**PRELIMINARY SAFETY AND ENVIRONMENTAL
INFORMATION DOCUMENT**

LIGHT-WATER REACTORS

January 1980

**NONPROLIFERATION ALTERNATIVE SYSTEMS
ASSESSMENT PROGRAM**

Figure B-2. Core power distribution early in a near-equilibrium cycle (30,000 MWd/t, 3-batch cycle).

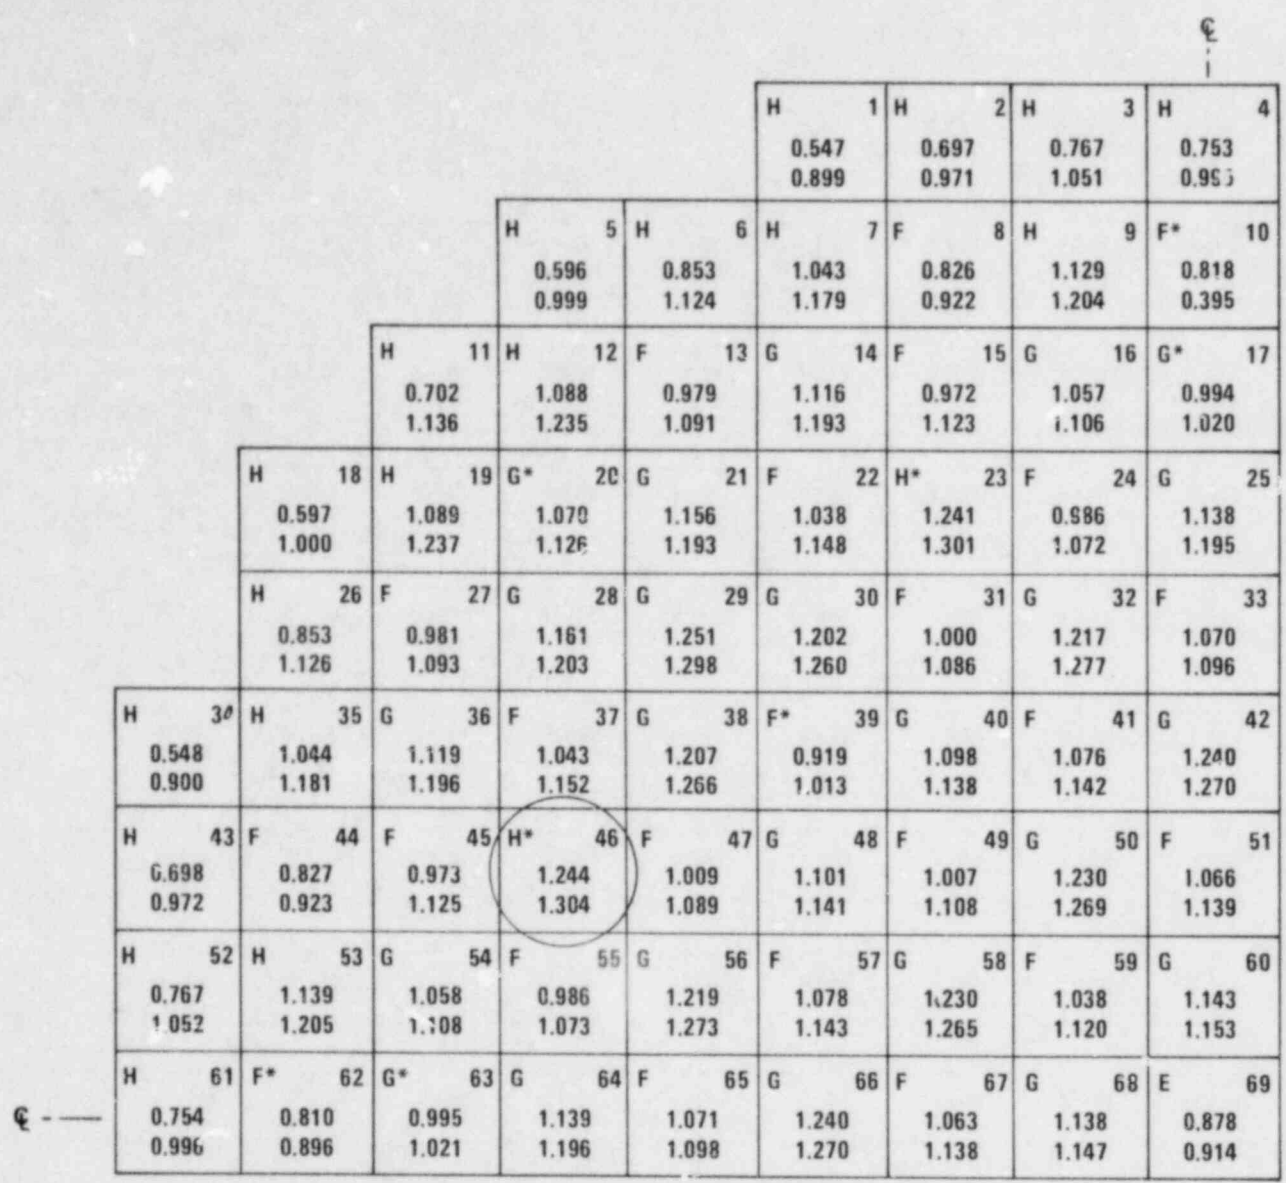
The present enrichment limit for fuel handling and storage at PWR plants is 4%. What approach does the DOE intend to take in these areas in light of the increased enrichment (4.3%) for extended burnup cores?

Licensing of fuel handling and storage will have to be reviewed by the reactor owners as part of their reload submittal to the NRC. In the very near term, this will occur for a few extended burnup demonstration assemblies. Similar requirements for a full core will not occur before about 1990. By this time, it is anticipated that
